HISTORIC AND DESIGN REVIEW COMMISSION

HDRC CASE NO: 2023-434
ADDRESS: 801 LABOR ST
LEGAL DESCRIPTION: NCB 733 BLK 5 LOT 8 & N 50 FT OF 7 ARB A8
ZONING: RM-4, H
CITY COUNCIL DIST.: 1
DISTRICT: Lavaca Historic District
APPLICANT: Michelle Hipps-Cruz/LIMINAL Design Studio
OWNER: LOCKE-MACIAS CHRISTINA ANN & RODOLFO MACIAS
TYPE OF WORK: Construction of a 2-story rear accessory structure
APPLICATION RECEIVED: December 01, 2023
60-DAY REVIEW: January 30, 2024
CASE MANAGER: Rachel Rettaliata

The applicant is requesting a Certificate of Appropriateness to construct a 2-story, 800-square-foot rear accessory structure.

STREET VIEW STUDIES

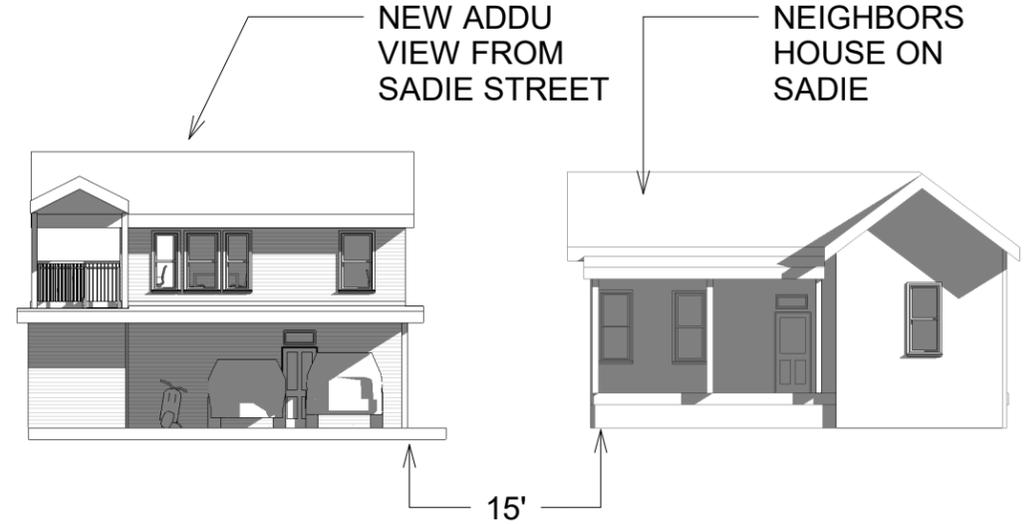
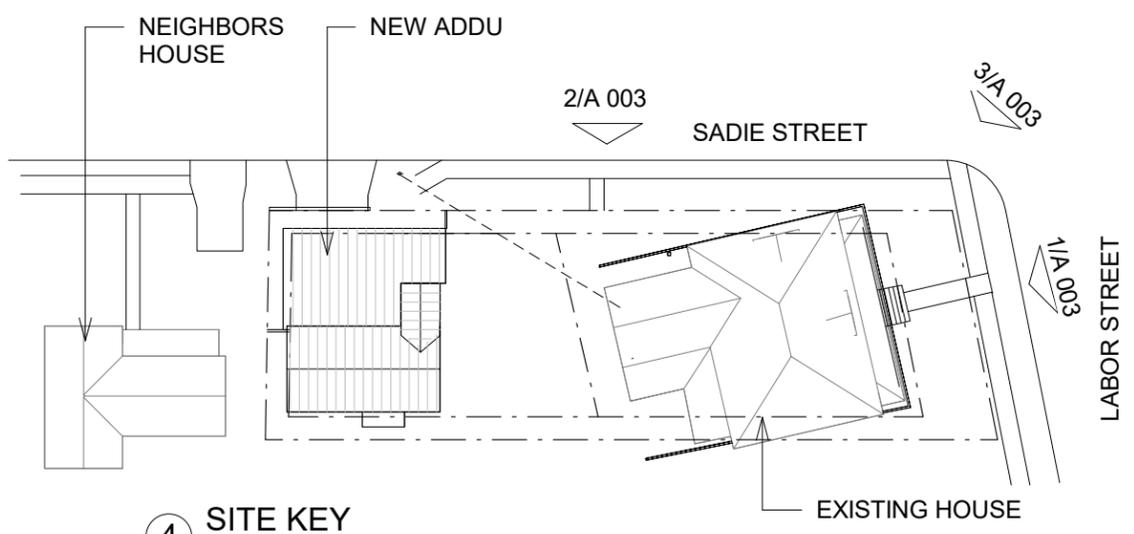
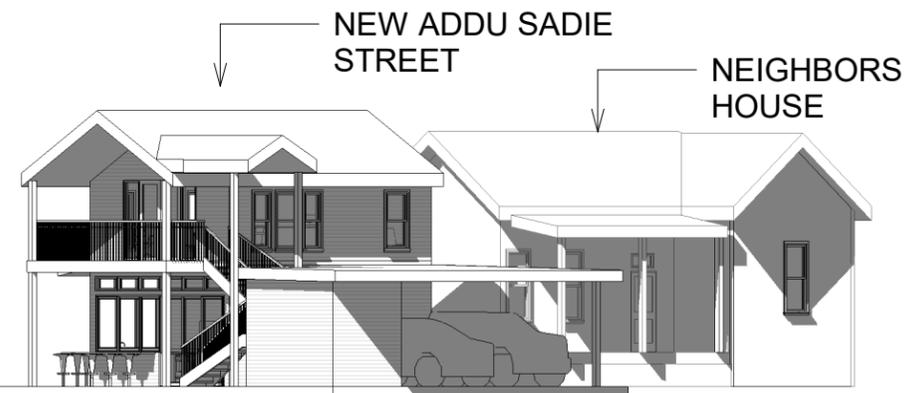
- i. That the applicant submits updated drawings that include the neighboring property for context to staff for review prior to returning to the HDRC based on finding c. ***This stipulation has been met.***

- d. NEW CONSTRUCTION: SCALE & MASS – Per the Guidelines for New Construction 2.A.i., a height and massing similar to historic structures in the vicinity of the proposed new construction should be used. The applicant has proposed a 2-story rear accessory structure. Adjacent properties predominately feature 1-story rear accessory structures. The applicant has proposed a structure that will total 24 feet in height. The primary structure is 25 feet in height. The applicant has provided a line-of-sight diagram showing that the structure will not exceed the height of the primary structure. Staff finds that the height of the rear accessory structure should be further reduced to comply with the Guidelines and to be subordinate to the neighboring primary structure and the block face.

- i. That the applicant further reduces the height of the rear accessory structure based on finding d and submits updated drawings that include the neighboring property for context to staff for review prior to returning to the HDRC.
- ii. That the applicant installs a standing seam metal roof that features panels that are 18 to 21 inches wide, seams that are 1 to 2 inches high, a crimped ridge seam, and match the current finish or a standard galvalume finish based on finding f. Panels should be smooth without striation or corrugation. Ridges are to feature a double-munch or crimped ridge configuration; no vented ridge caps or end caps are allowed. All chimney, flue, and related existing roof details must be preserved. An inspection must be scheduled with OHP staff prior to the start of work to verify that the roofing material matches the approved specifications.

SITE PLAN

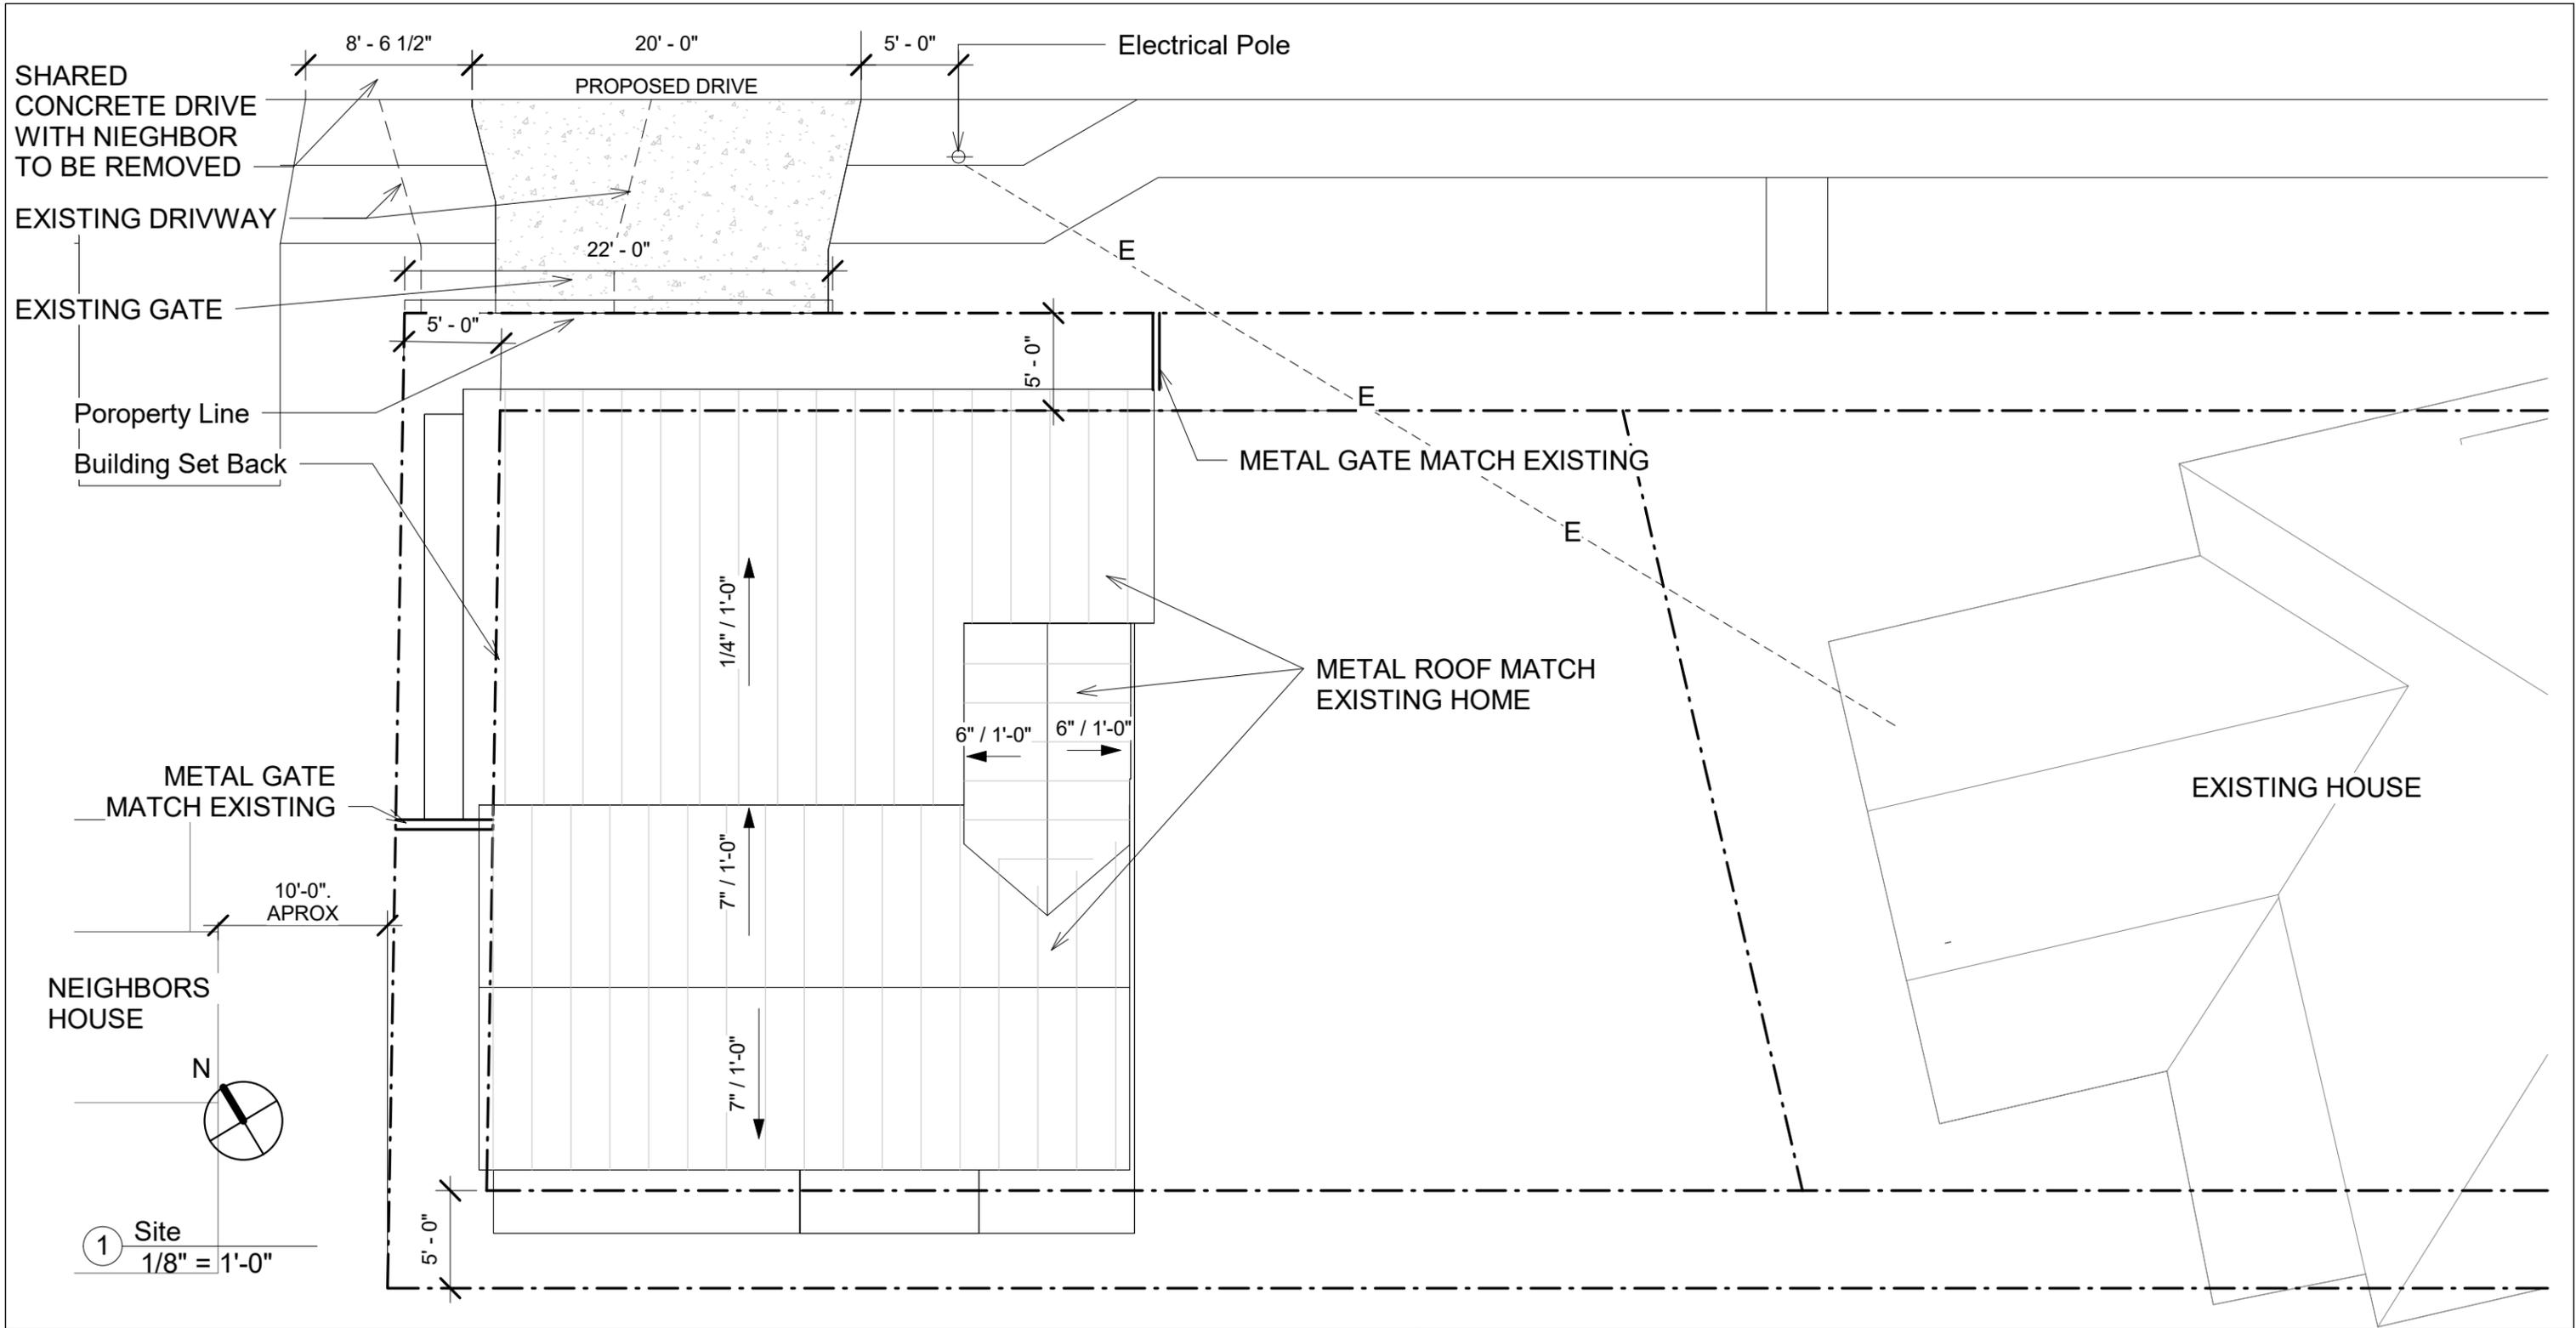
x. That the applicant updates the driveway and driveway apron modifications to feature an apron that is recentered on the proposed new driveway. ***This stipulation has been met.***

- l. DRIVEWAY MODIFICATIONS – The applicant has proposed to modify the existing driveway apron, which appears to measure 12 feet in width, to 20 feet in width and to install 5 feet of a 22-foot-wide driveway from the modified driveway apron to a new 581-square-foot concrete pad and a 518-square-foot carport. According to Guideline 5.B.i for Site Elements, historic driveway configurations should be retained and repaired in place. Applicants should incorporate a similar driveway configuration—materials, width, and design—to that historically found on the site. Historic driveways are typically no wider than 10 feet. Pervious paving surfaces may be considered where replacement is necessary to increase stormwater infiltration. The HDRC conceptually approved the previously requested driveway with the stipulation that the driveway apron is recentered on the proposed new driveway. Staff finds that the applicant has met the HDRC stipulation from the conceptual review.

WEST ELEVATION

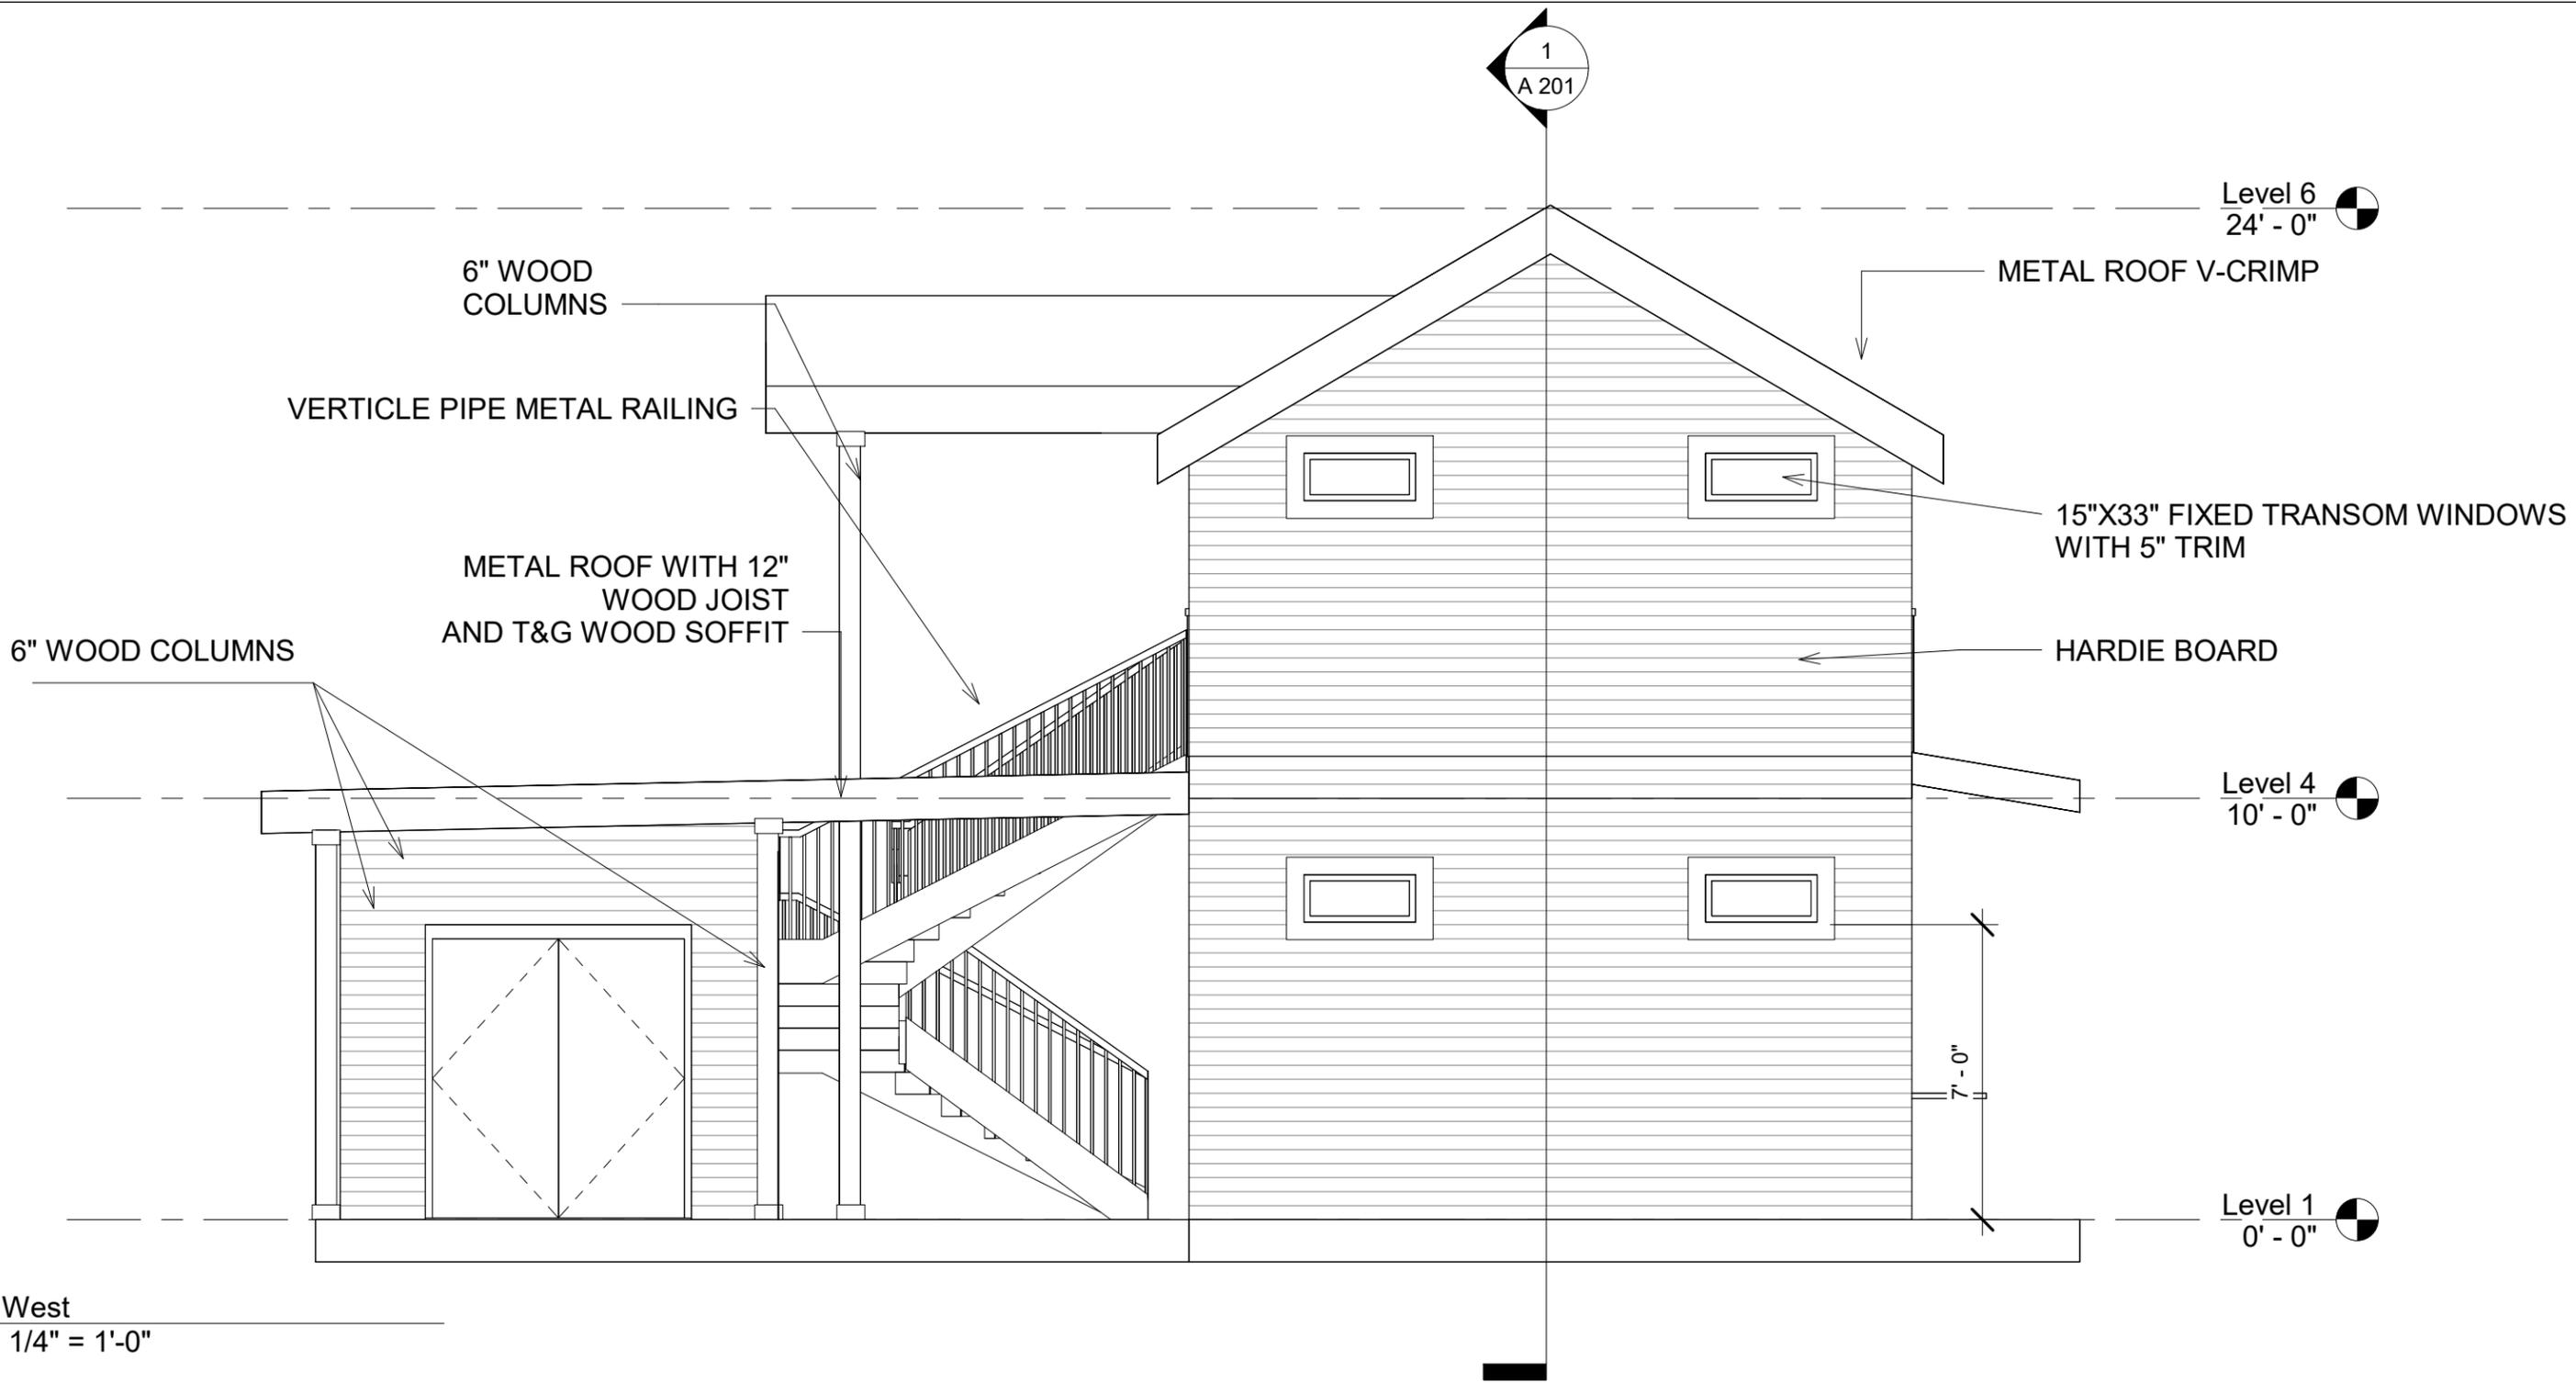
- iv. That the applicant proposes window sizes, patterns, proportions, operations and trim and sill detailing on the west elevation that are consistent with the Guidelines and historic precedents in the district as noted in finding g and submits updated elevation drawings to staff for review and approval prior to returning to the HDRC based on finding g. ***This stipulation has NOT been met on the west elevation.***

- h. NEW CONSTRUCTION: WINDOW OPENINGS – Per the Guidelines for New Construction 2.C.i., window and door openings with similar proportions of wall to window space as typical with nearby historic facades should be incorporated into new construction. The applicant has proposed to install one-over-one windows of traditional proportions, fixed transom windows on the west elevation, and a telescoping glass window on the first floor of the south and east elevations, and a row of transom windows above the east elevation. Staff finds

that the applicant should propose a fenestration pattern on the west elevation that features traditional window proportions that are more in keeping with the Guidelines.

- iii. That the applicant proposes window sizes, patterns, proportions, operations and trim and sill detailing on the west elevation that are consistent with the Guidelines and historic precedents in the district as noted in finding g and submits updated elevation drawings to staff for review and approval prior to returning to the HDRC based on finding h.

① COLUMN DETAIL
1/2" = 1'-0"

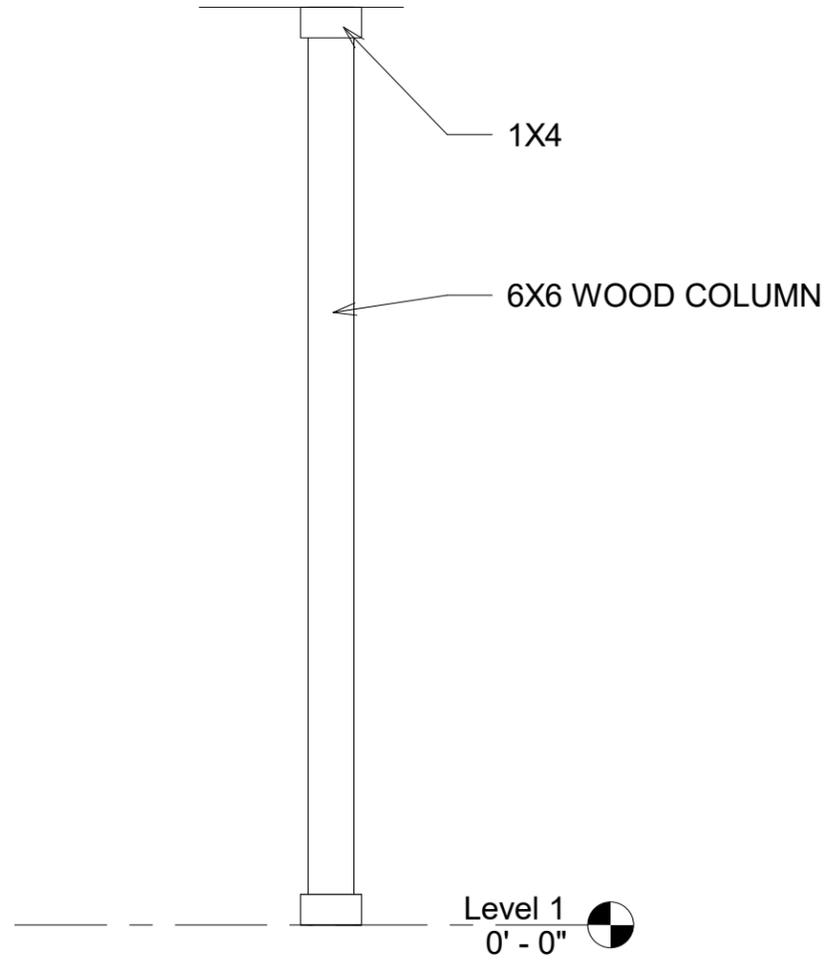
viii. That the applicant submits column details based on finding i showing that the proposed porch and carport columns will be fully wood to staff for review prior to returning to the HDRC. The porch columns should feature a maximum of 6x6” in width and feature a traditional cap and base and chamfered corners. ***This stipulation has been met and will remain through to final review.***

- vii. That the proposed columns are fully wood and feature a maximum of 6x6” in width and a traditional cap and base and chamfered corners based on finding j.
